HISTORIC AND DESIGN REVIEW COMMISSION

HDRC CASE NO: 2017-467
ADDRESS: 423 N HACKBERRY ST
LEGAL DESCRIPTION: NCB 576 BLK 15A LOT N 30.32 FT OF 12
ZONING: RM-4 H
CITY COUNCIL DIST.: 2
DISTRICT: Dignowity Hill Historic District
APPLICANT: John Brearley
OWNER: John and Irene Brearley
TYPE OF WORK: New construction of a 2-story single family home
REQUEST:

The applicant is requesting conceptual approval to construct a new two-story single family home on the vacant lot at 423 N Hackberry.

ADDRESS: 423 NORTH HACKBERRY ST.

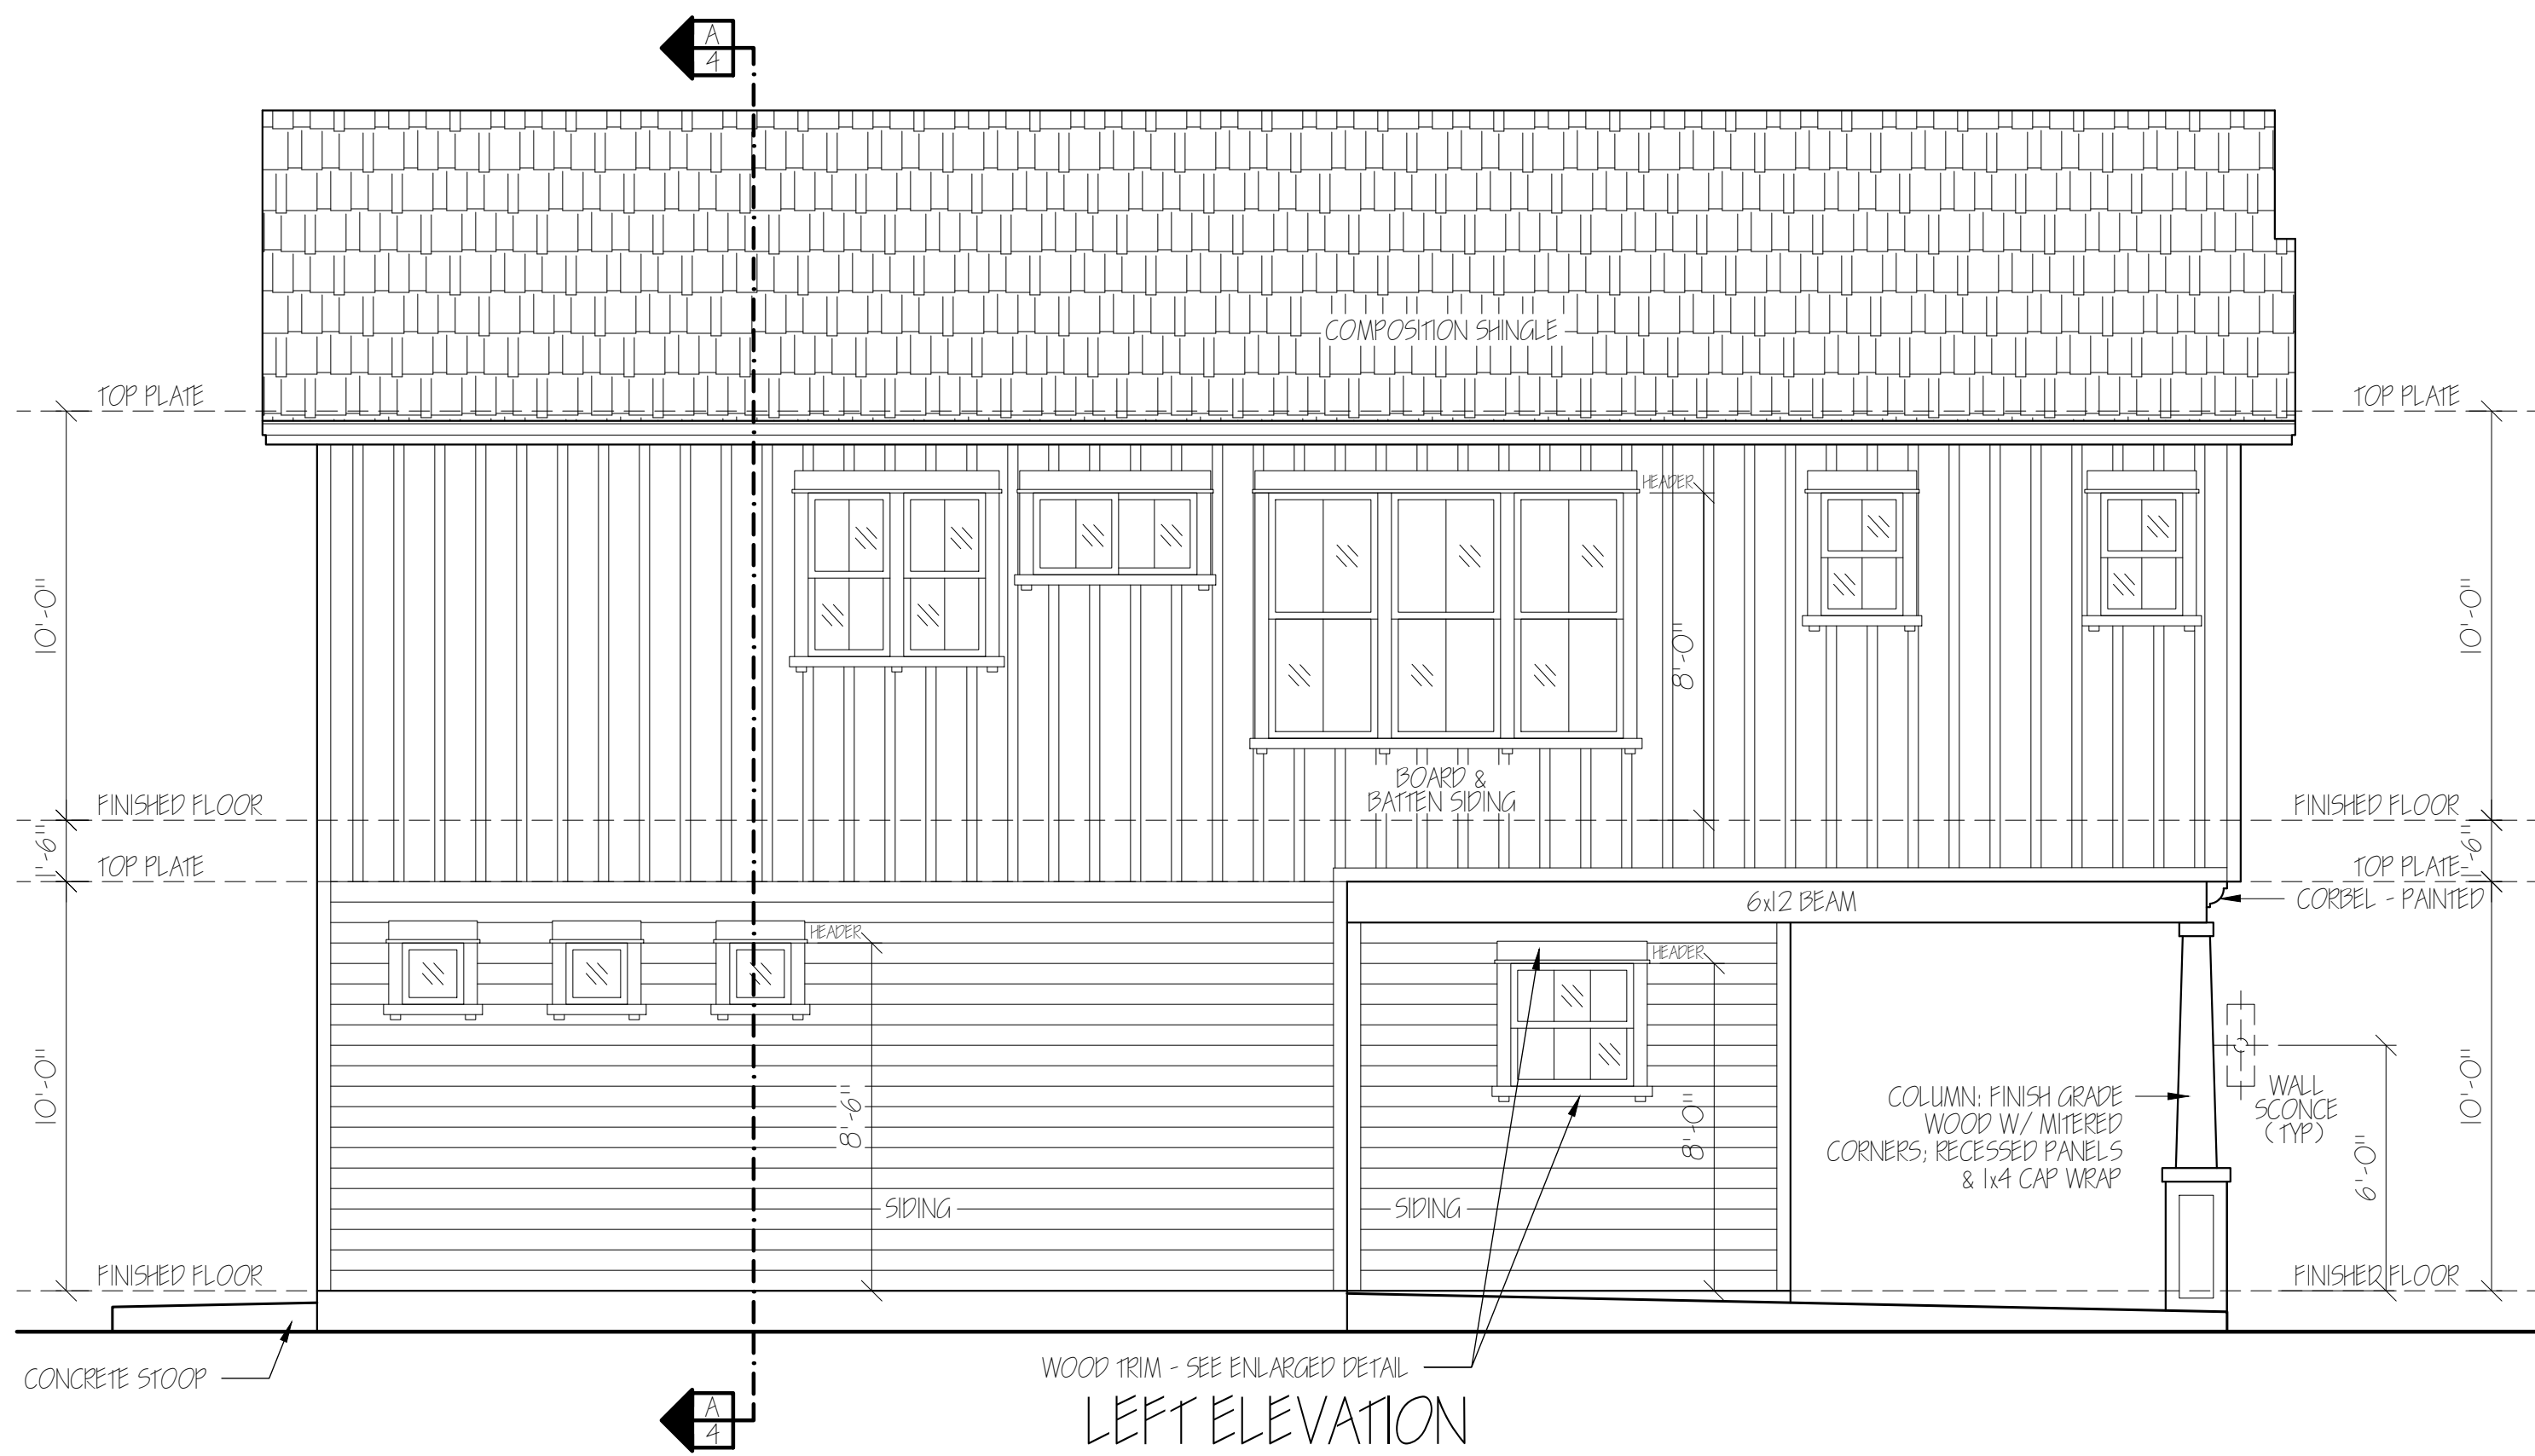
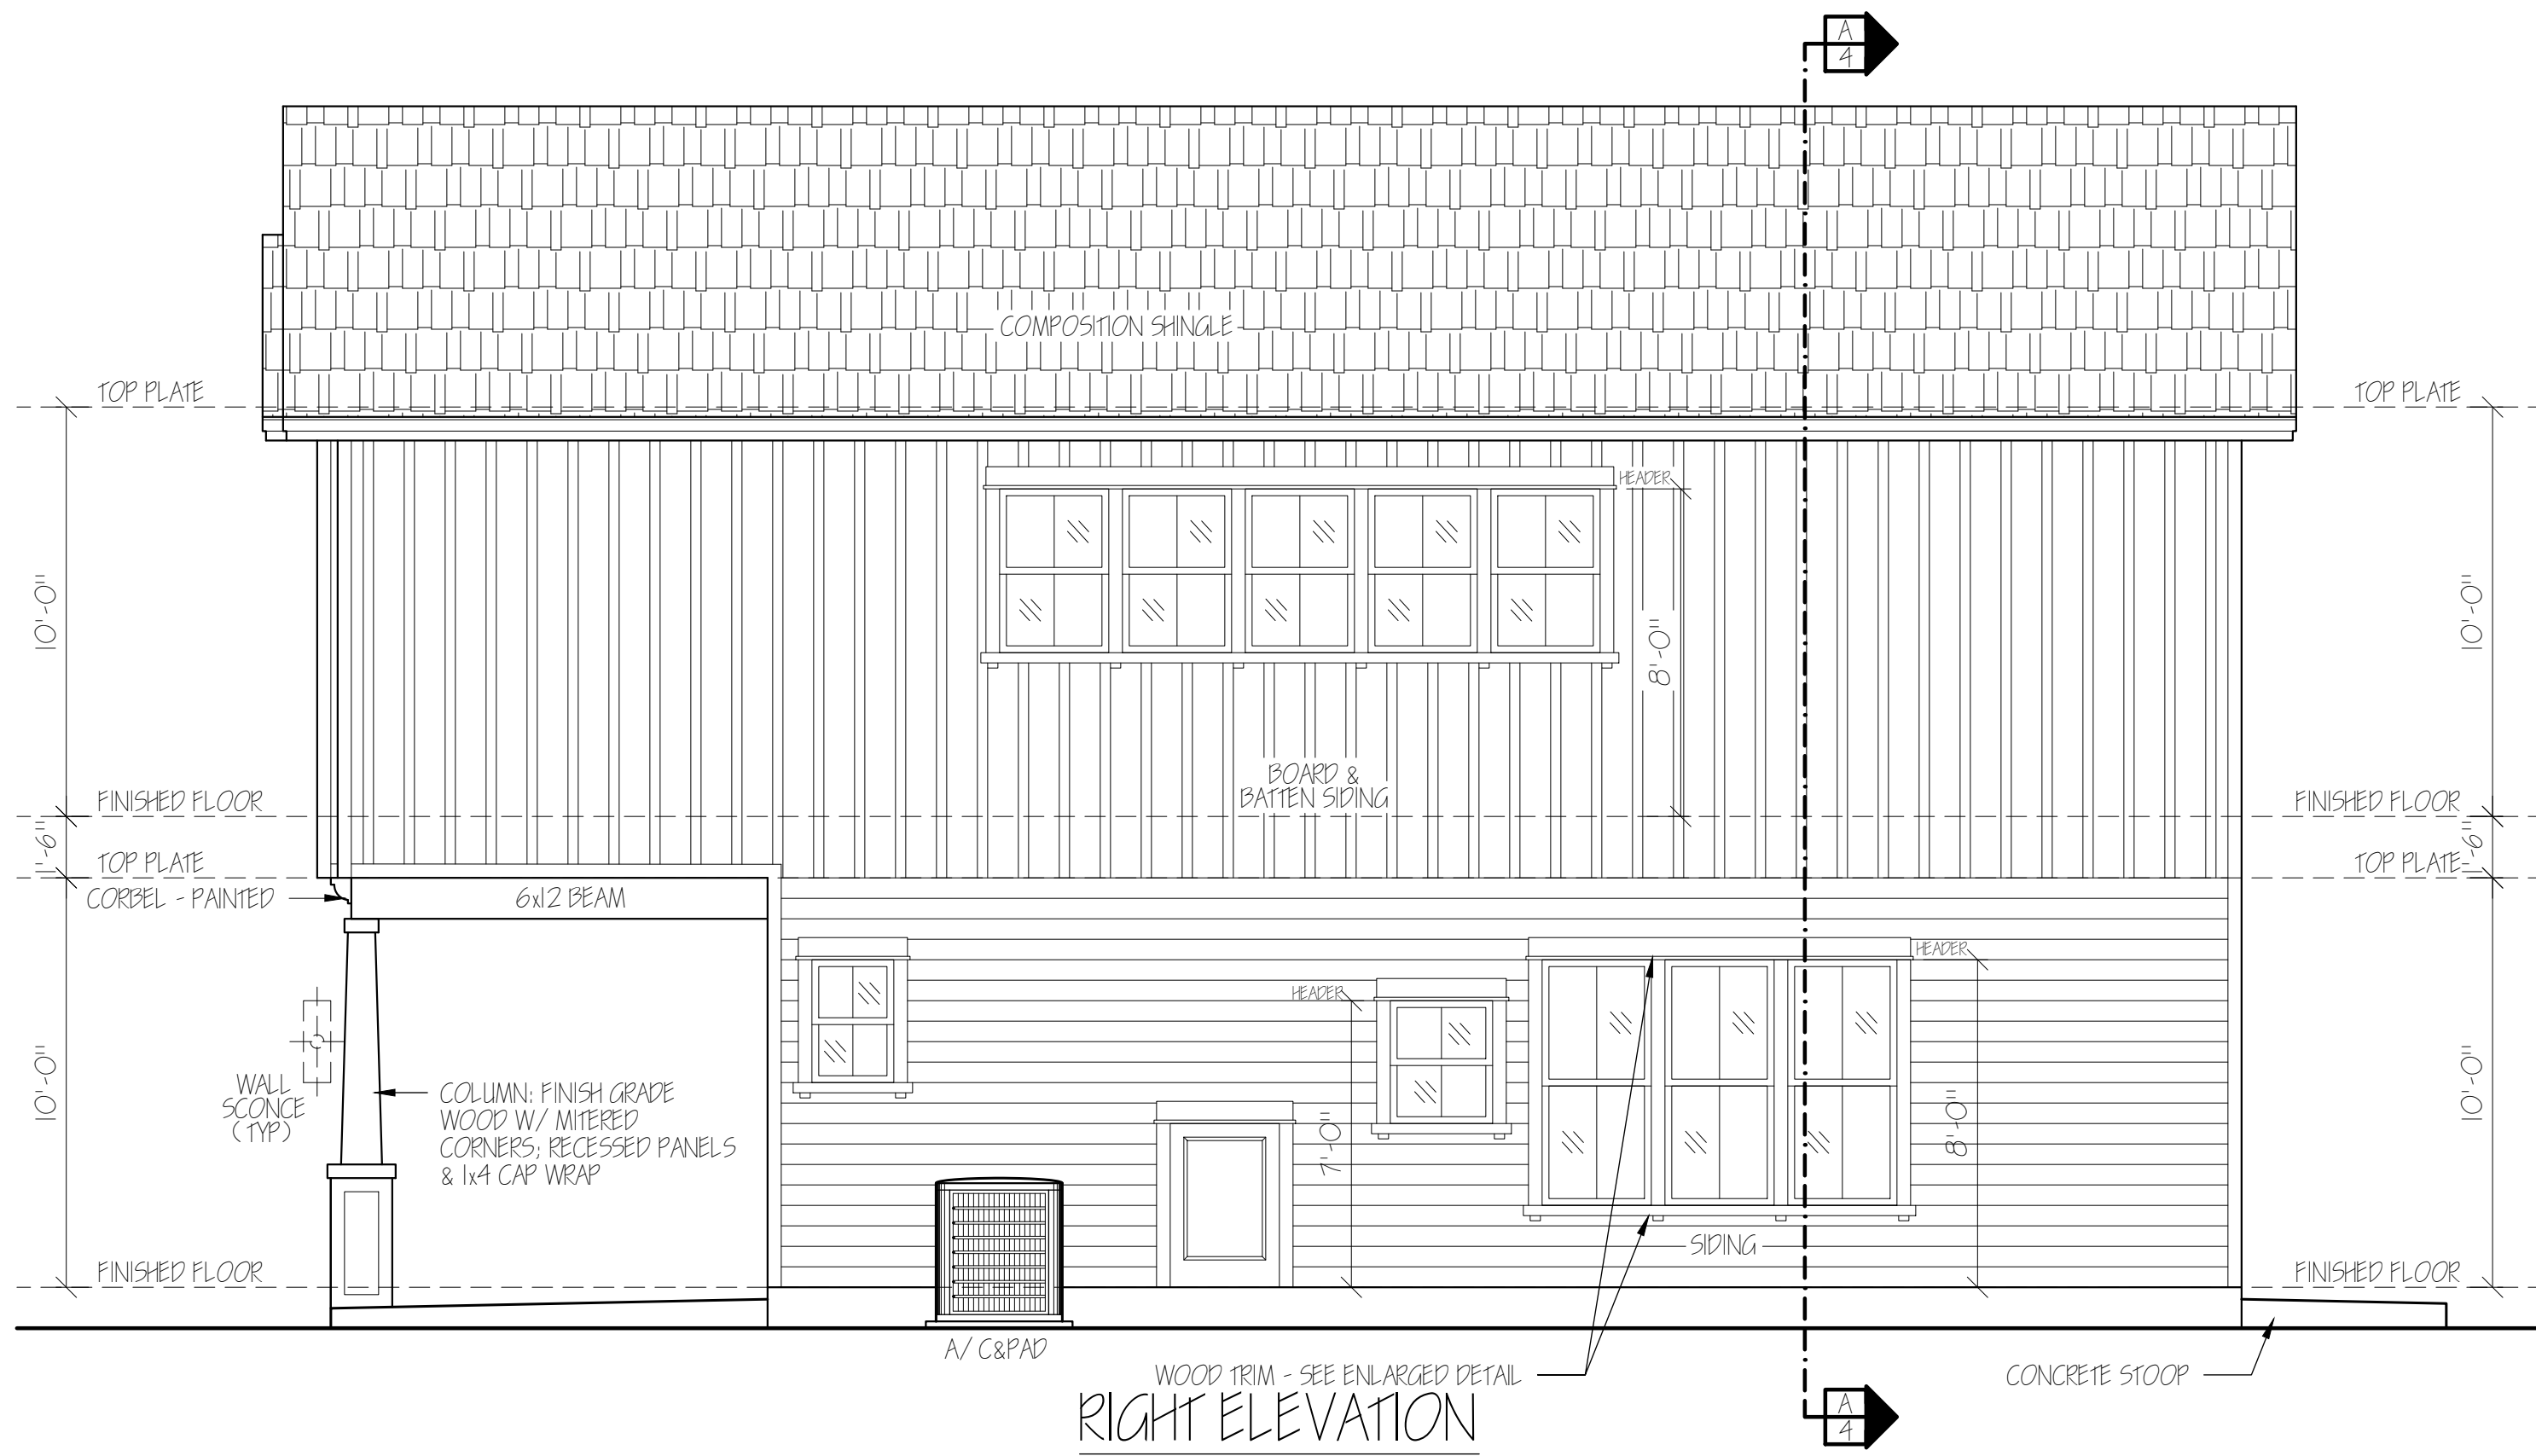
those found on historic structures in regards to location and size with the exception of the right and left elevations, which feature several small fixed windows that are not consistent with the OHP Window Policy Document or historic fenestration precedents in the district, as well as a series of ganged windows with minimal trim separation between them. All proposed window detailing can be modified to relate closer to historic examples, such as the use of approximately six inches of separation between double windows. Each window should be inset at least two (2) inches within walls to ensure that a proper façade depth is maintained.

COMMENTS/CONCERNS: Updated drawing - includes
small front balcony. Plus a fake window
under carport. Issue of no windows on one
side; issue of a fake window in new construction.
Needs to have windows. Small window in bathroom,
not large enough - focus on pattern, consistency.
Fewer windows placed strategically.
Balance pattern, rigidity to window placement. →

4. That the proposed driveway extends along the side of the proposed new construction as noted in finding p.
5. That the applicant introduces window sizes and proportions that are more consistent with the Historic Design Guidelines, the OHP Window Policy Document, and adjacent historic structures to the right and left elevations as noted in finding i.
